dealer bulletin

Date: February 25, 2000
To: All Shasta Authorized Dealers
From: Joe Keil, Customer Service/Warranty Manager
RE: Recall #99V228
Priority:

This bulletin will provide additional information pertaining to Recall #99V228. An initial notice was mailed out February 8, 2000.

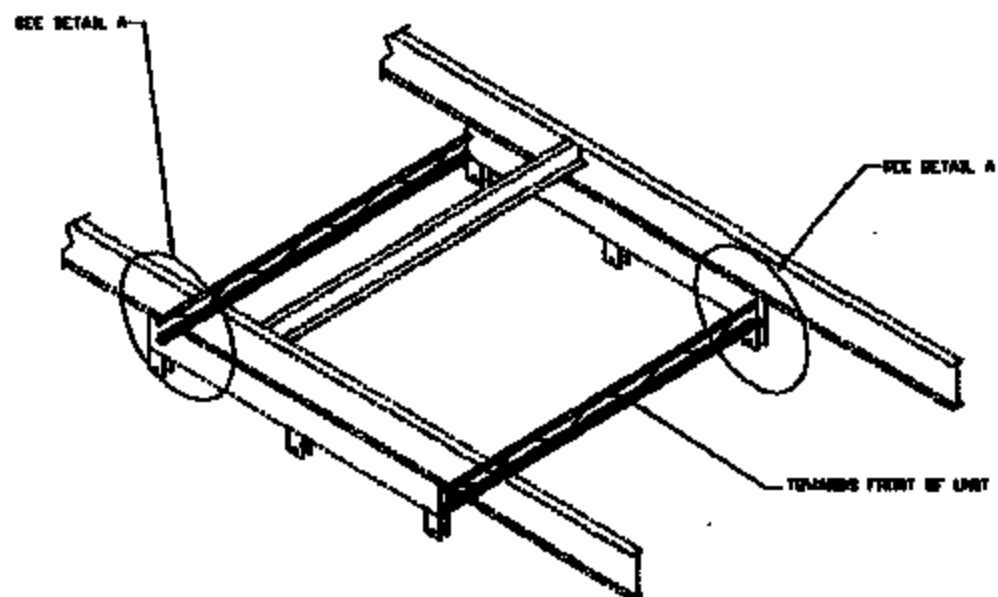
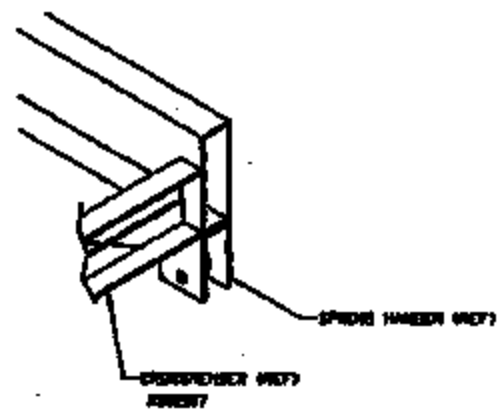
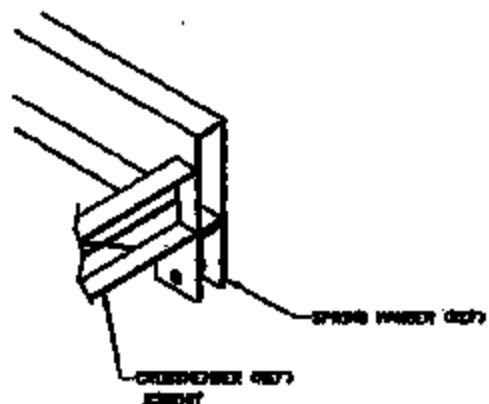
1. Inspect the frame. If the unit has rod and angle cross members (as shown in drawing #F1X2000) the recall is not needed. You may claim .2 for the inspection using Operation Code #1190V.

A) IS THERE A CROSS-MEMBER LOCATED BETWEEN THE LOWER FRAME TUBES AS SHOWN IN DETAIL "A" ? IF YES, THEN THIS PROCEDURE WILL NOT BE NECESSARY. IF THERE IS NOT A CROSS-MEMBER LOCATED AS DESCRIBED THEN FOLLOW THE NEXT STEP AS NOTED IN 1B).

5) PLACE THE APPROPRIATE CROSS-MEMBER INTO POSITION AS INDICATED IN DETAIL "B". IT SHOULD BE POSITIONED AND HELD IN PLACE WITH CLAMPS SO THAT HOLE LOCATIONS CAN BE MARKED ON THE FRAME TUBES FOR DRILLING IN STEP 6). IN SOME INSTANCES AN ABS DRAIN LINE WILL NEED TO BE CUT IN ORDER FOR THE CROSS-MEMBER TO BE PLACED INTO POSITION. IF THIS IS REQUIRED, IT IS TO BE RECONNECTED AT THE COMPLETION OF THE CROSS-MEMBER INSTALLATION.

7) REPOSITION THE CROSS-MEMBER AND BOLT INTO PLACE. IT SHOULD BE NOTED THAT A STEEL SLEEVE IS TO BE INSERTED INTO THE END OF THE TUBE SO THAT THE BOLT PASSES THROUGH IT. THIS WILL PREVENT THE TUBE FROM COLLAPSING WHEN THE NUT IS TIGHTENED.

8) WITH THE BOLTS, STEEL SLEEVES, FLAT WASHERS, LOCK WASHERS, AND NUTS IN PLACE AND THE CROSS-MEMBER INSTALLED IN POSITION THE NUTS SHOULD BE TIGHTENED TO 17 FT-LB.
